RE: Marsh Landing Generating Station
Application for Certification 08-AFC-03

Responses to Data Request Set 3b: (#99-101)

Application for Certification (08-AFC-03) for MARSH LANDING GENERATING STATION Contra Costa County, California

REVISED FIGURE 62-1a

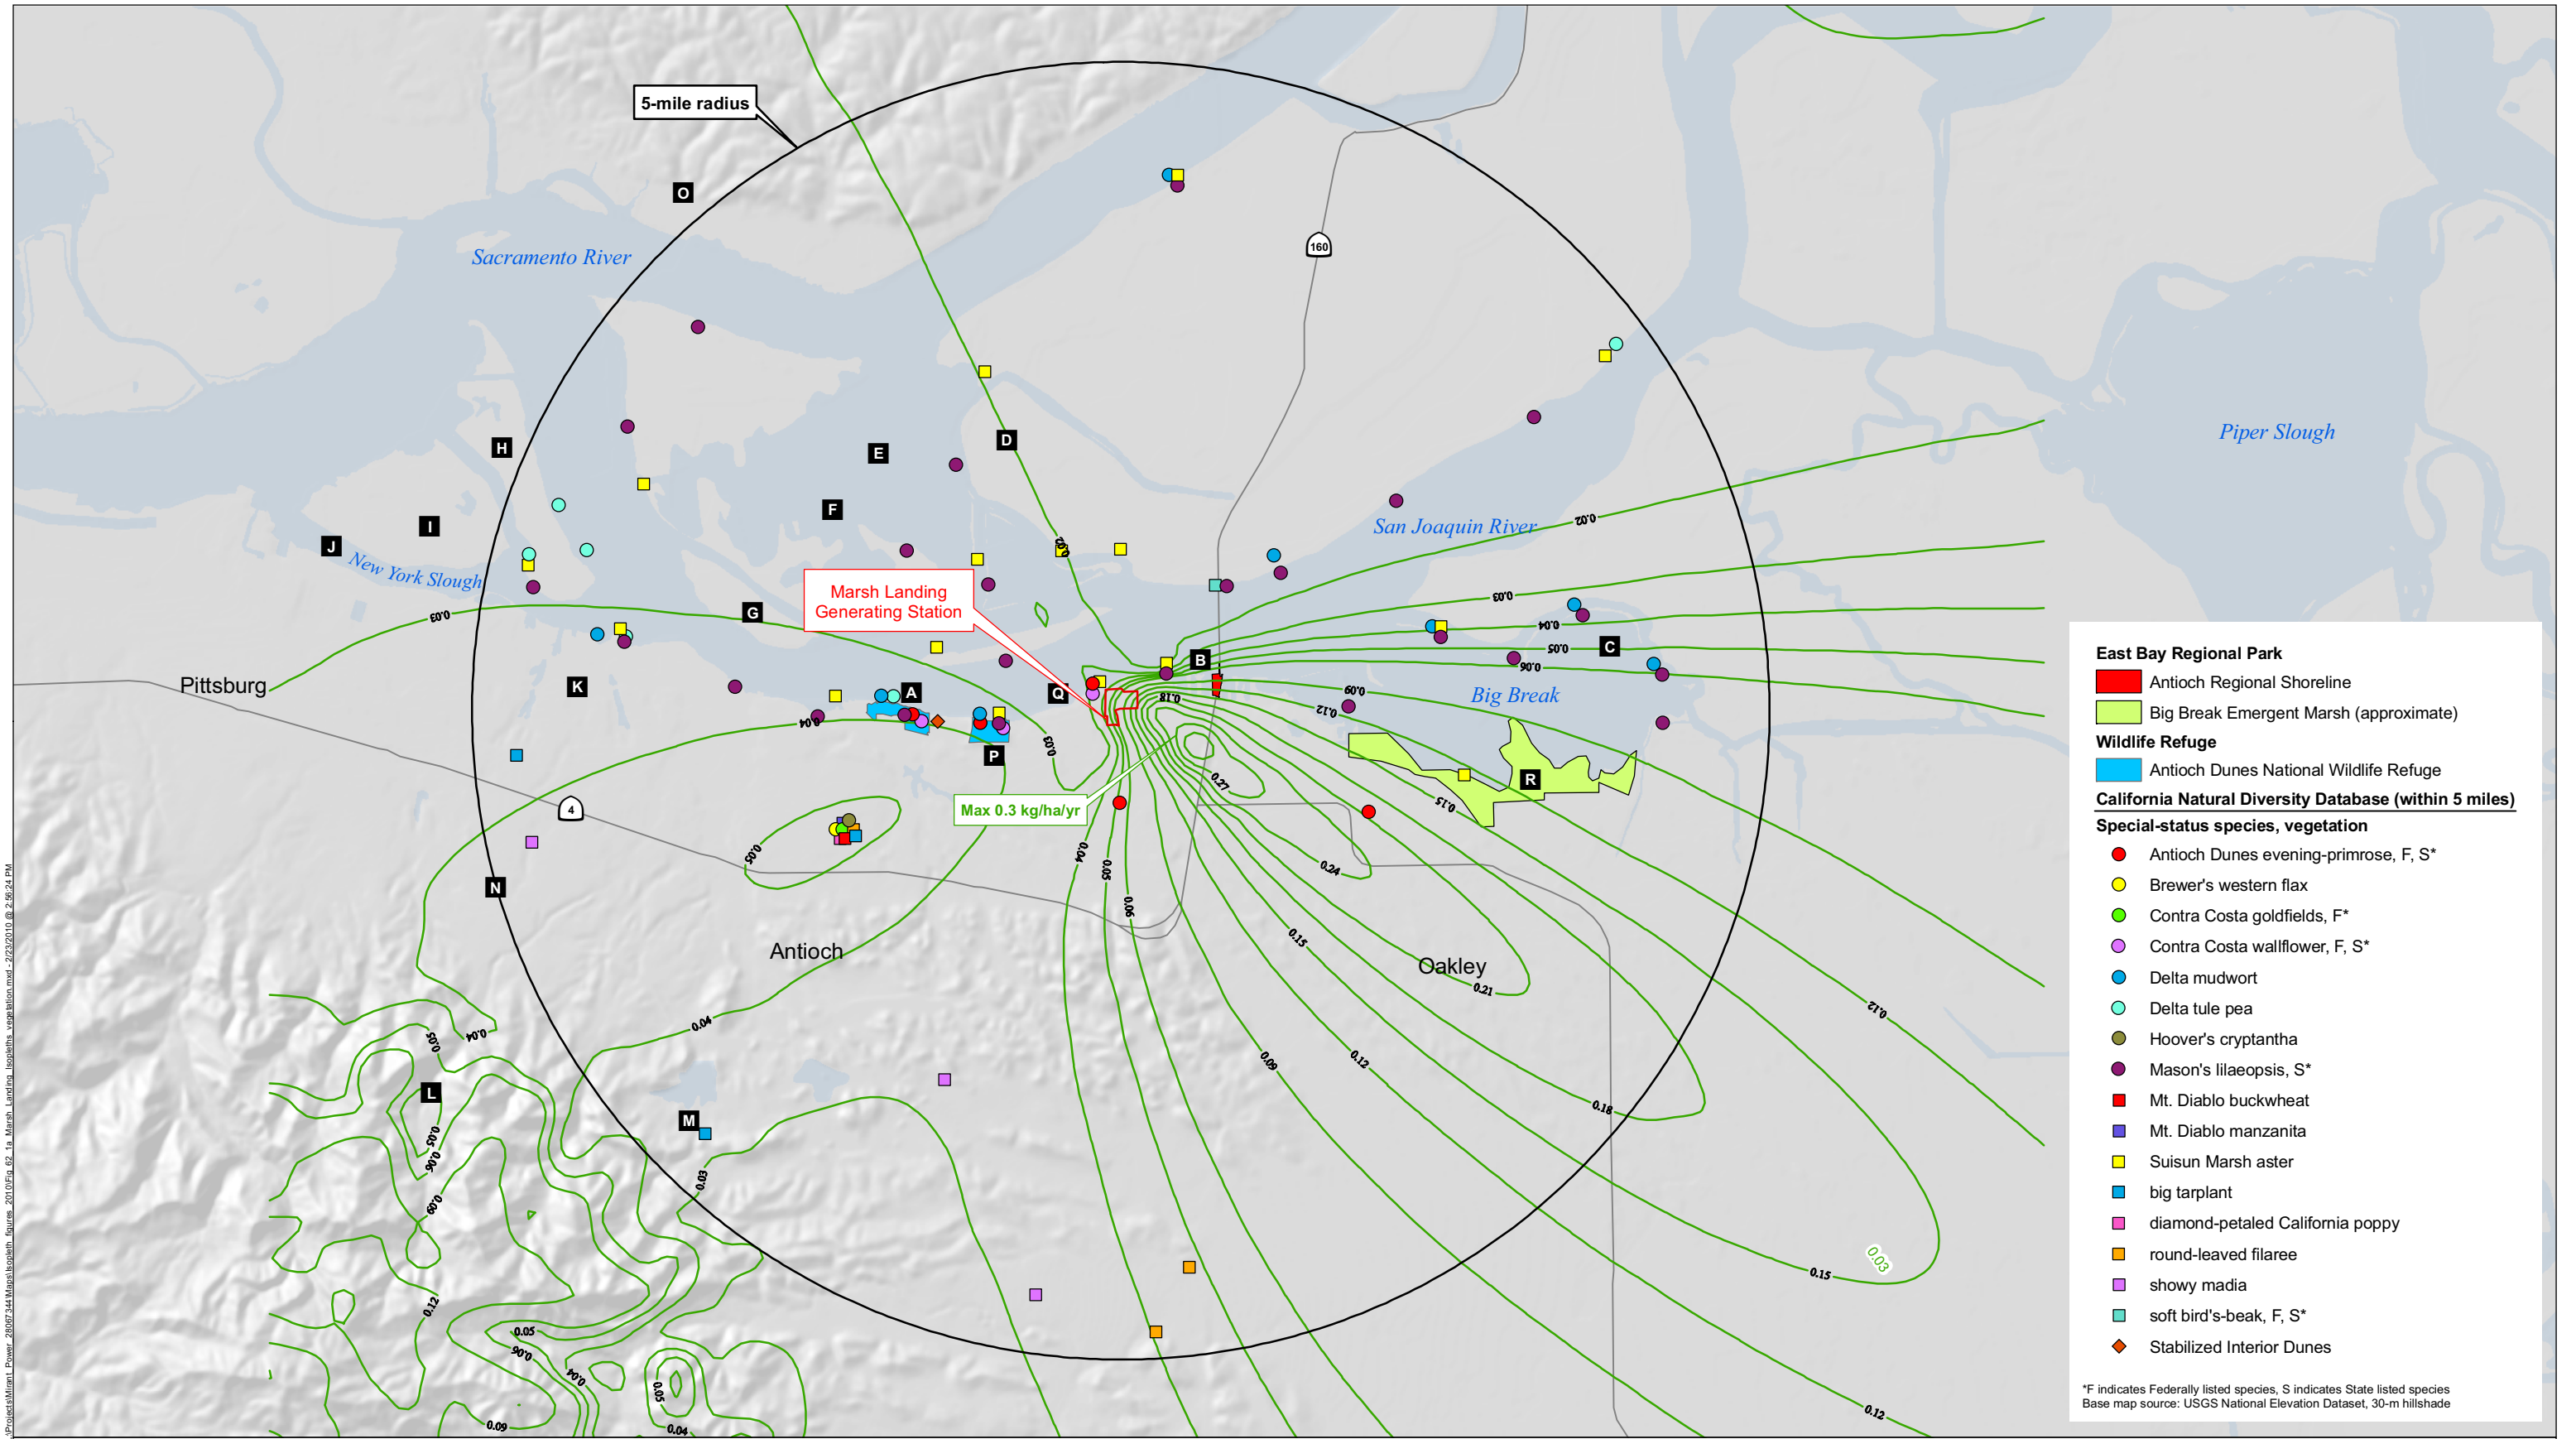
99 *Please provide an analysis of impacts due to total nitrogen deposition from operation of the MLGS. The analysis should specify the amount of total nitrogen deposition in kg/ha/yr at:*

- a. the Sardis Unit and Stamms Unit of the Antioch Dunes National Wildlife Refuge;*
- b. the freshwater/brackish marsh habitat north of the project area along the San Joaquin River shoreline; and*
- c. all other "Areas of Concern" (B through R) as illustrated in AFC Figure 7.2-1.*

100 *Please provide an isopleth graphic over USGS 7.5-minute map(s) (or equally detailed map) of the direct nitrogen deposition rates caused by the project that graphically depicts the results.*

As illustrated in Revised Figures 62-1a and 62-1b, nitrogen deposition rates from MLGS at the Sardis Unit and Stamms Unit of the Antioch Dunes National Wildlife Refuge (NWR) are between

0.03 and 0.04 kg/ha/yr. With background, the maximum nitrogen deposition rate for the Antioch Dunes NWR is 1.64 kg/ha/yr.

In the freshwater/brackish marsh habitat north of the project area along the San Joaquin River shoreline, nitrogen deposition rates are between 0.02 and 0.03 kg/ha/yr. With added background, the maximum modeled nitrogen deposition rate for this area is estimated to be 1.63 kg/ha/yr. Tidal marshes have high biomass production and accumulation, in addition to tidal processes that help control nutrient fluxes. They also have nitrogen fluxes an order of magnitude higher than many other systems and are not particularly sensitive to nitrogen deposition (Rozema et al., 2000).

Revised Figures 62-1a and 62-1b provide the isopleths for nitrogen deposition rates due to the proposed project. Revised Figure 62-1a shows the federal and state listed special-status vegetation species. Revised Figure 62-1b shows the federal and state listed wildlife special-status species.

REVISED FIGURE 63-1a

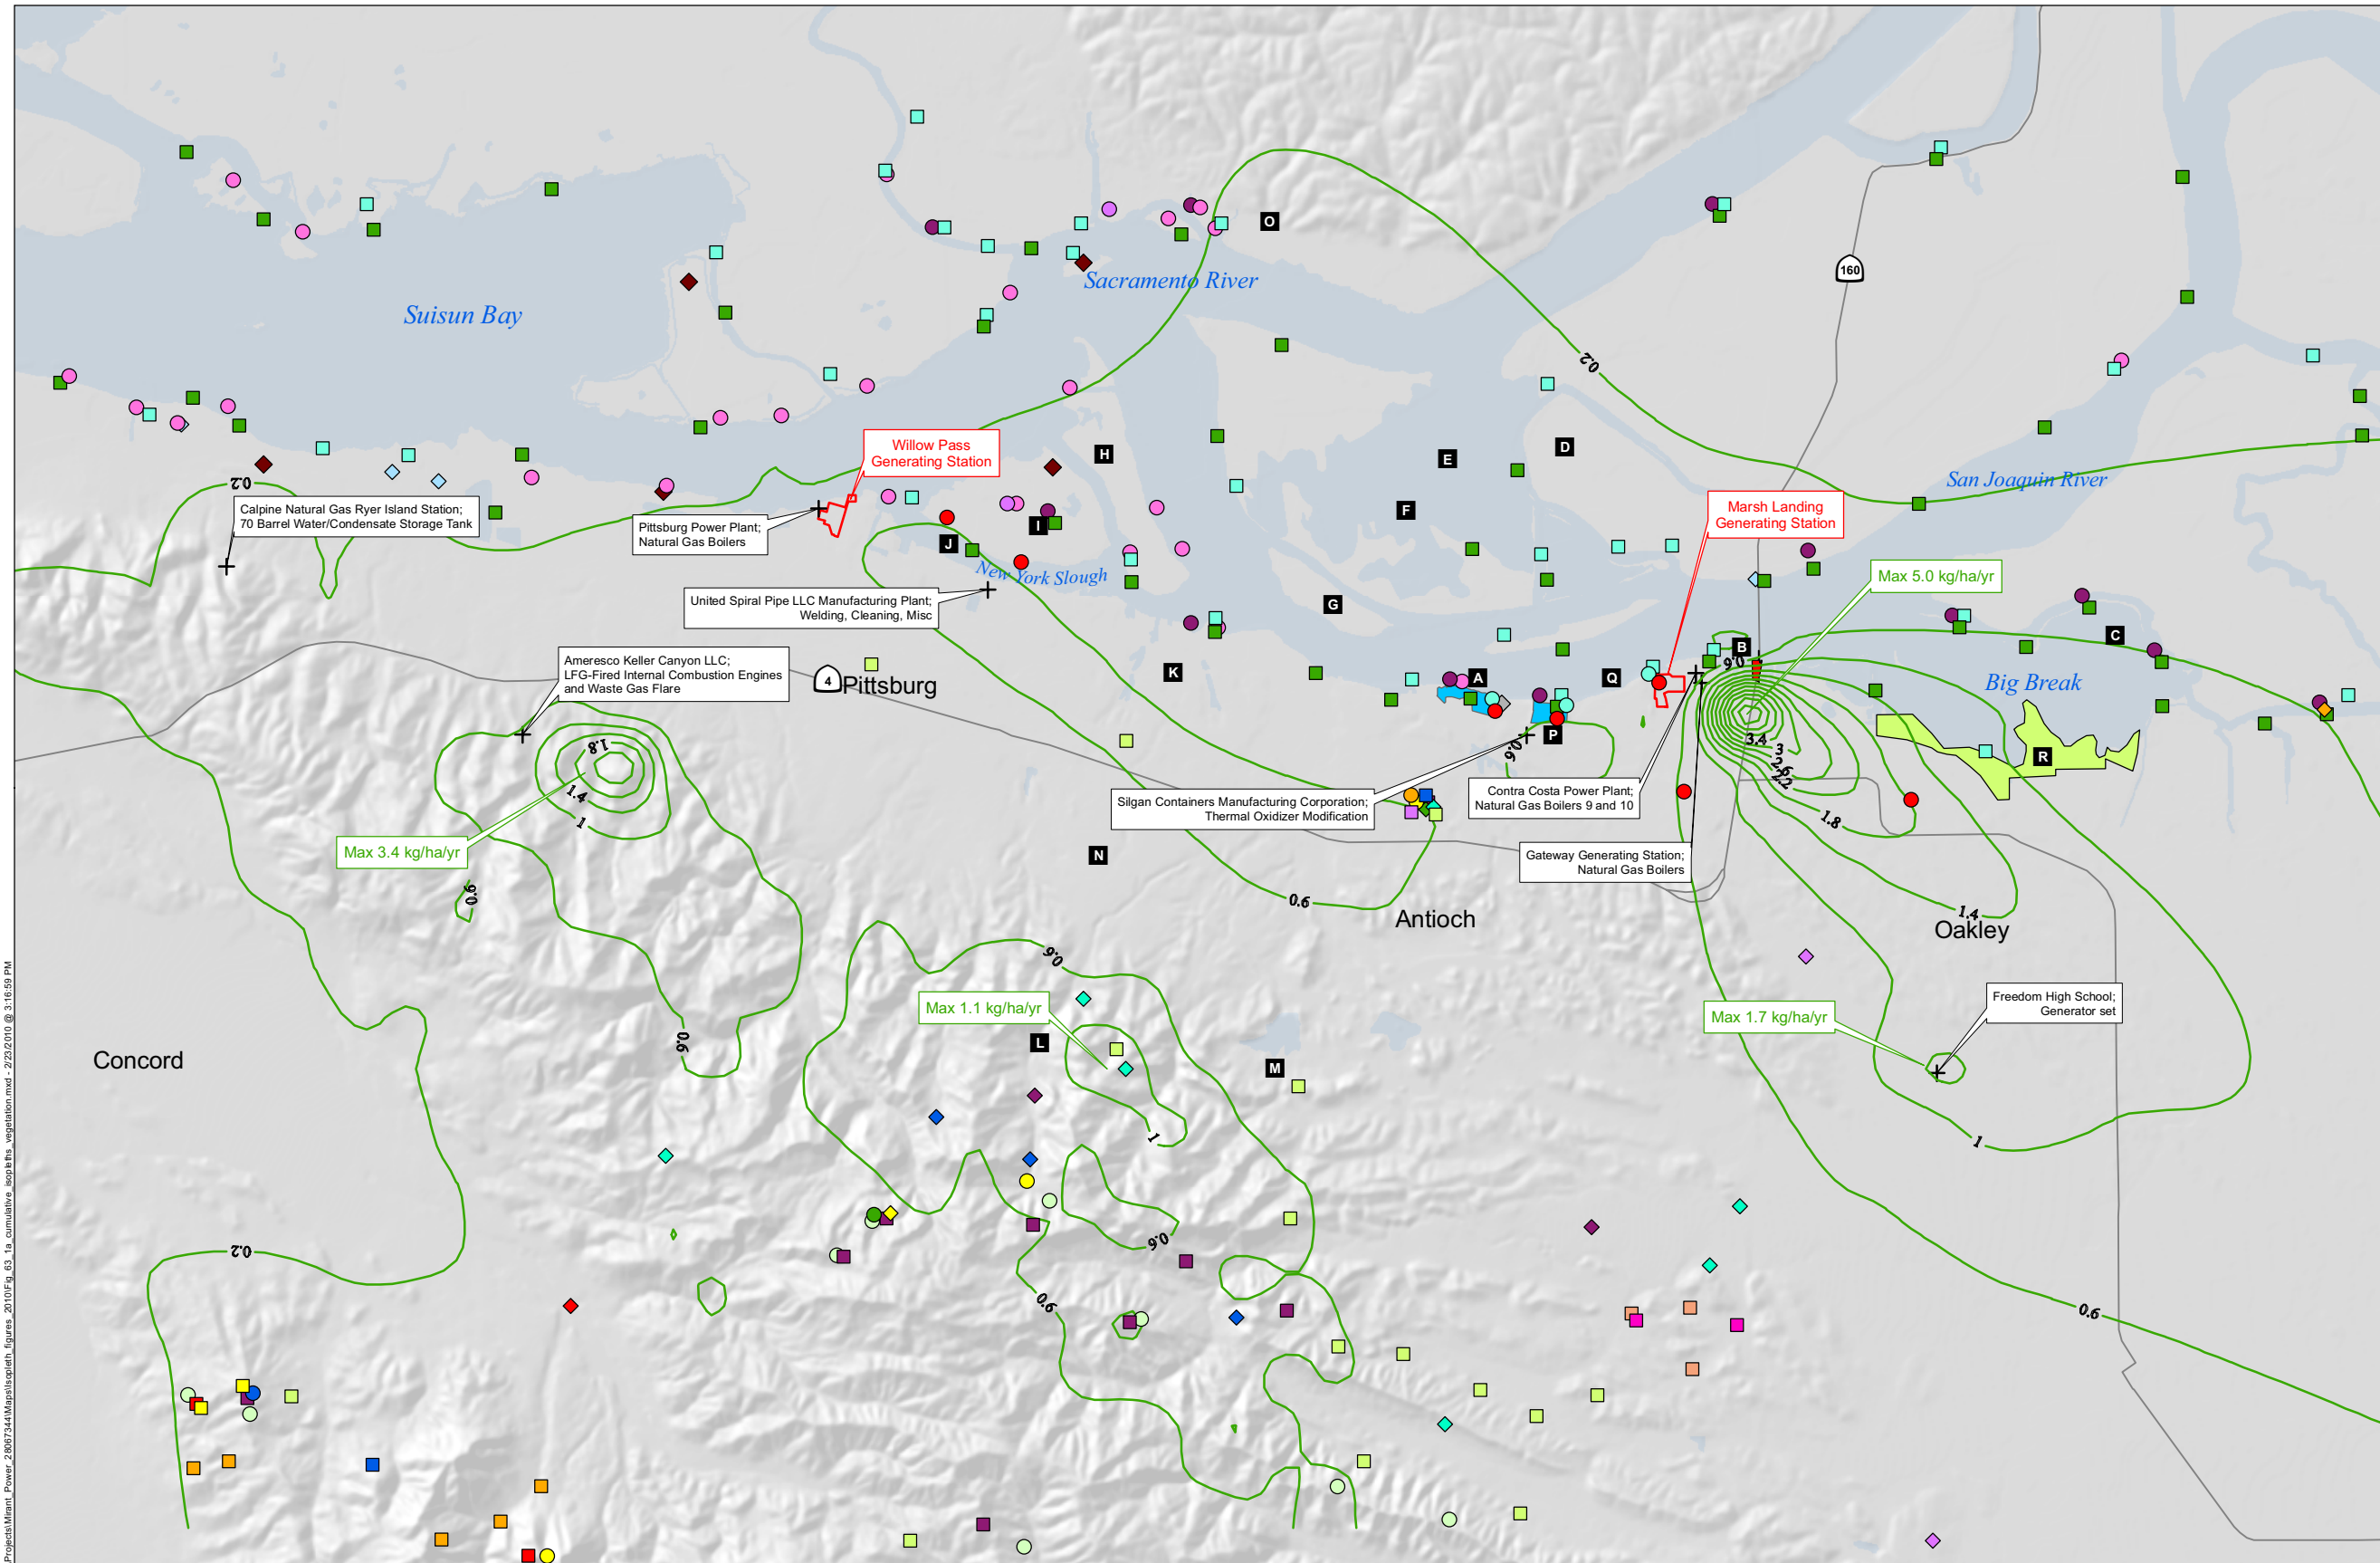
101 *Please update the cumulative impact analysis (Tables 9-1 and 9-2) in Responses to Data Request Set #1 – data request #9 – with nitrogen deposition values in kg/ha/yr. Provide an isopleth graphic over USGS 7.5-minute maps (or equally detailed map) of the direct nitrogen deposition values in the cumulative analysis.*

Revised Figures 63-1a and 63-1b provide the isopleths for nitrogen deposition rates in kg/ha/yr due to all cumulative sources listed in Revised Table 63-1. Revised Figure 63-1a shows the federal and state listed special-status vegetation species. Revised Figure 63-1b shows the federal and state listed special-status wildlife species.

As seen in Revised Figures 63-1a and 63-1b, the maximum cumulative nitrogen deposition value occurs approximately 0.5 mile southeast of the MLGS facility. The maximum nitrogen deposition rate for all cumulative sources is estimated to be 5.0 kg/ha/yr (without background) in this area. This area would exceed the benchmark of 5 kg/ha/yr with background, but it is not considered sensitive to nitrogen deposition because sands or serpentine soils are not known to be present. Almost all of the highest nitrogen deposition rates in this area are caused by nitrous oxide and NH₃ emissions from the Gateway Generating Station.

The area with the next highest value is in the hills south of Pittsburg, more than 9 miles southwest of the MLGS project site near the Ameresco Keller Canyon LLC facility. The estimated maximum cumulative nitrogen deposition rate is 3.4 kg/ha/yr without background or 5 kg/ha/yr with background. The elevated nitrogen deposition values in this area are largely associated with emissions from sources at the Ameresco Keller Canyon LLC facility, which includes two landfill gas-fired internal combustion engines and a waste gas flare. This area is not considered sensitive to nitrogen deposition because sands or serpentine soils are not known to be present.

- An area near the Black Diamond Mines Regional Preserve (Area L on the figures); and
- An area around the Freedom High School Generator.

However, the cumulative nitrogen deposition in these areas is estimated to be below 5 kg/ha/yr with background. Cumulative nitrogen deposition values in the hills near Black Diamond Mines Regional Preserve (Area L on the figures) are largely associated with emissions of NH₃ and nitrogen oxides from the Gateway Generating Station. The maximum value in this area without background is 1.1 kg/ha/yr. The other localized nitrogen deposition area is the region around the Freedom High School generator set. The localized maximum value near the Freedom High School generator set is 1.7 kg/ha/yr without background.
